From: BRYAN Martin (EXTERNAL AREVA) [Martin.Bryan.ext@areva.com]
Sent: Friday, August 06, 2010 4:18 PM
To: Tesfaye, Getachew
Cc: ROMINE Judy (AREVA); BENNETT Kathy (AREVA); GUCWA Len (EXTERNAL AREVA); RYAN Tom (AREVA); WILLIFORD Dennis (AREVA); RANSOM James (AREVA); NOXON David (AREVA); Carneal, Jason
Subject: DRAFT Response to U.S. EPR Design Certification Application RAI No. 372, FSAR Ch. 6, Question 6.2.5-15
Attachments: RAI 372 Supplement 3 Response DRAFT.pdf

**Request for Additional Information No. 372(4388, 4328, 4389), Revision 1
Supplement 3**

U. S. EPR Standard Design Certification

Question 06.02.05-15:

Figure 06.02.05-15-1—Containment Temperature (Dome) with Hydrogen Burning

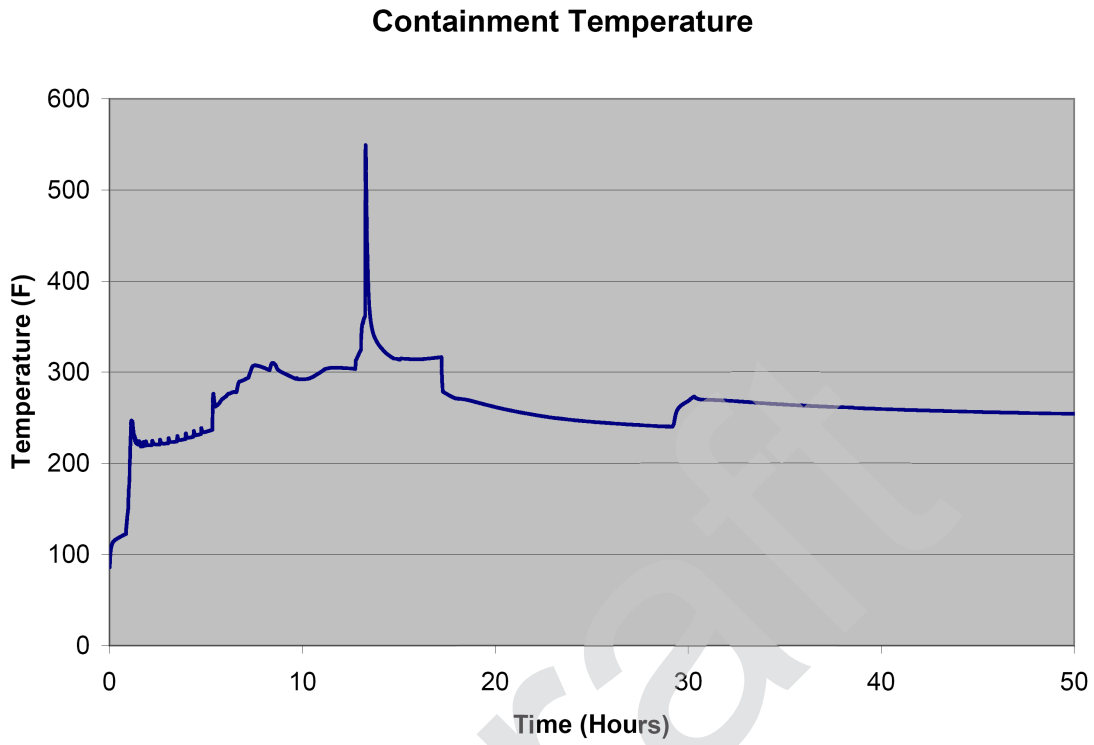
Provide the pressure and temperature conditions in containment during hydrogen burning that these instruments and components would be subject to. Identify design features, test results, or analyses which would confirm the equipment survivability.

Based on the more likely severe accident scenarios identified in ANP-10268P-A, Revision 0, MAAP4 calculations were prepared to derive limiting pressure and temperature load profiles resulting from hydrogen combustion during a severe accident in the U.S. EPR design. The results of this calculation are provided in this response. Figure 06.02.05-15-1 and Figure 06.02.05-15-2 present the temperature and pressure time history in the dome in case of hydrogen burning.

During a severe accident sequence with associated hydrogen burning, temperature and pressure spikes, although of short duration, are predicted (see Figure 06.02.05-15-1 and Figure 06.02.05-15-2). These temperature and pressure excursions surpass the qualification profiles used for the qualification under 10CFR50.49. The containment isolation valves are closed early during the accident sequence prior to the predicted hydrogen burn. The valve function to close and isolate the containment is not impacted, and maintaining leak-tightness is the main criterion for a severe accident survivability evaluation.
